Colston Budd Rogers & Kafes Pty Ltd

16 December, 2020

RE: STATE SIGNIFICANT DEVELOPMENT APPLICATION FOR
PROPOSED CUSTOMER FULFILLMENT CENTRE
11-13 PERCY STREET, AUBURN

Heavy Vehicle Truck Route Plan

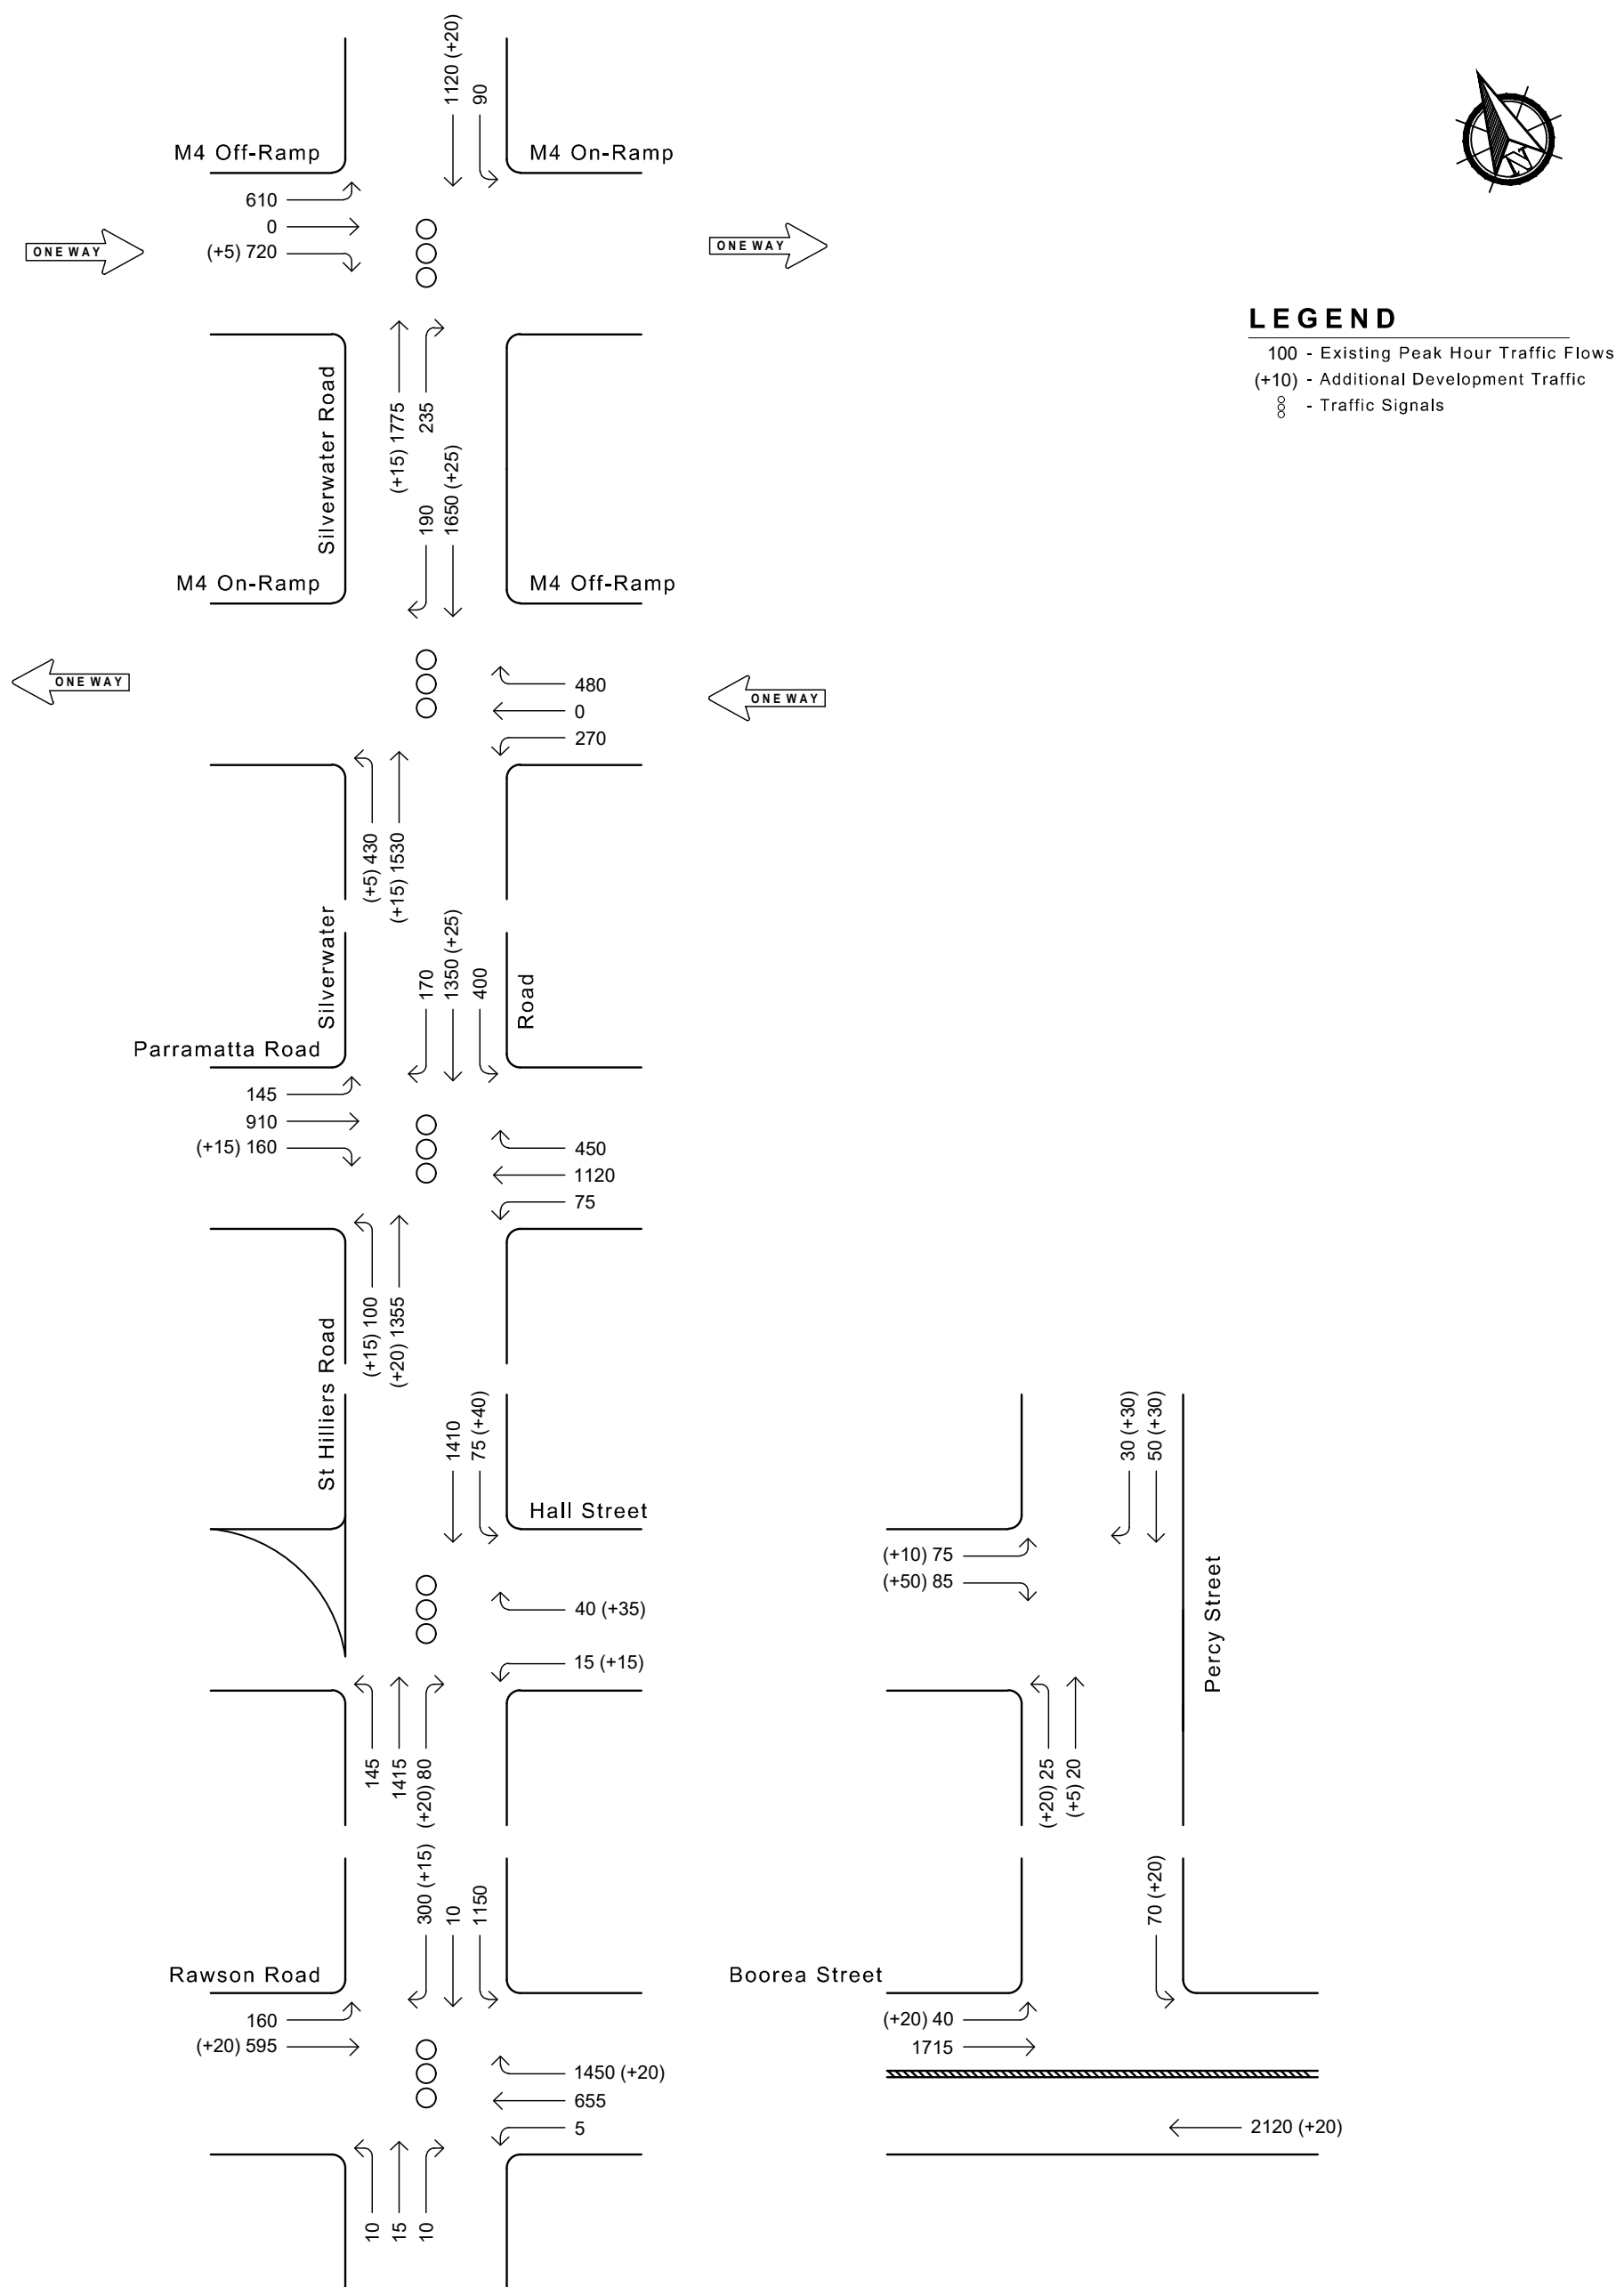
- *The development will increase heavy vehicular movements in the local area, potentially impacting the residential area to the north-west of the site. Please consider restricting truck movements to Percy Street, avoiding residential areas along St Hilliers Road. Such restrictions could be proposed through the implementation of a Driver Code of Conduct.*

- As per SEARs, the EIS should include “details of access to, from and within the site to/from the local road and strategic (motorway) network; and a Traffic Impact Assessment (TIA) including a description of vehicle access routes and the impacts on nearby intersections.” However, the detail of heavy vehicle route description has not been included in the EIS or TIA. Furthermore, traffic count as well as intersection assessment of A44/A6 and M4/A6 have not been provided.

- *Section 3.28 of the TIA indicates that “Inbound deliveries to the online fulfilment centre will be made by semi-trailers up to 20 metres long”. 20m semi-trailer is not a general access vehicle and will require a permit (PBS) to operate. Left turn from Parramatta Road to Percy Street is not permitted for heavy vehicles exceeding 19 metres in length. Also, Percy Street is not on a PBS level 1 network.*

21. Large service vehicles accessing the site will be restricted to the designated heavy vehicle truck routes, as shown on Figure 6. The truck routes will restrict articulated vehicles to the main road network and ensure that large service vehicles do not access residential streets in the vicinity of the site.

- Further information in regards to the above comment should be provided as part of the Responses to Submissions.
24. As discussed above, large service vehicles accessing the site, including semi-trailers, will be restricted to the designated heavy vehicle truck routes, as shown on Figure 6. These routes include the following:

- M4 Motorway, Silverwater Road, St Hilliers Road, Hall Street and Percy Street; and
 - Olympic Drive, Boorea Street, St Hilliers Road, Hall Street and Percy Street.
